## **REMARKS**

### **IN THE DRAWINGS**

Fig. 3A

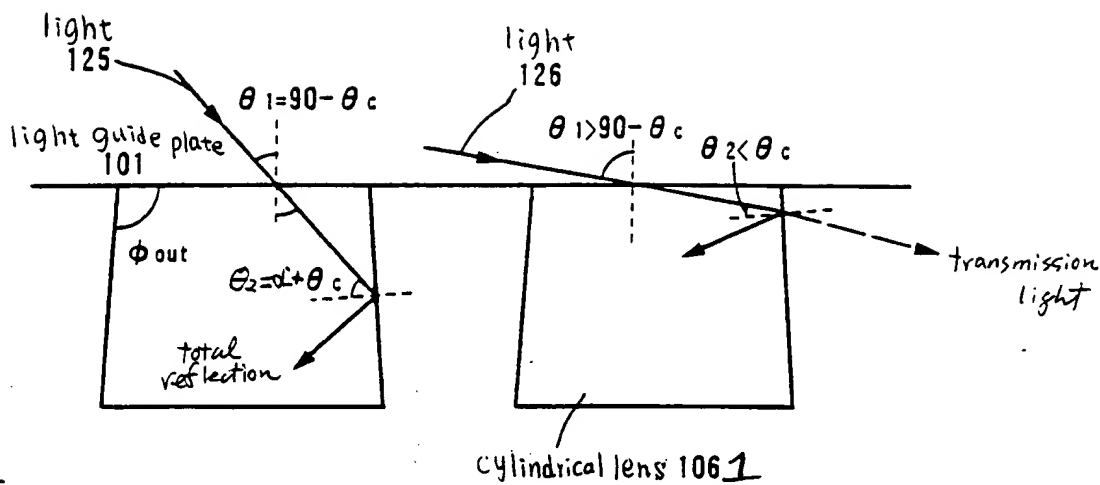
The Examiner also states that reference character “106” has been used to designate different parts in different embodiments and refers to Figures 1A, 3A, 3B and 3C. In response, Applicant is amending “106” to “1061” in Fig. 3A, amending “106” to “1062” in Fig. 3B, and amending “106” to “1063” in Fig. 3C. In addition, Applicant is amending the specification to recite “1061” after “prism-shaped lenses “ on page 16, line 5, “1062” after “prism-shaped lenses “ on page 16, line 7, and “1063” after “prism-shaped lenses “ on page 16, line 10. Accordingly, it is respectfully requested that this objection be withdrawn.

The attached sheets of drawings include changes to Figs. 3A-3C so that each does not use the reference character "106" to designate different parts in the different figures. Applicant is also submitting formal drawings.
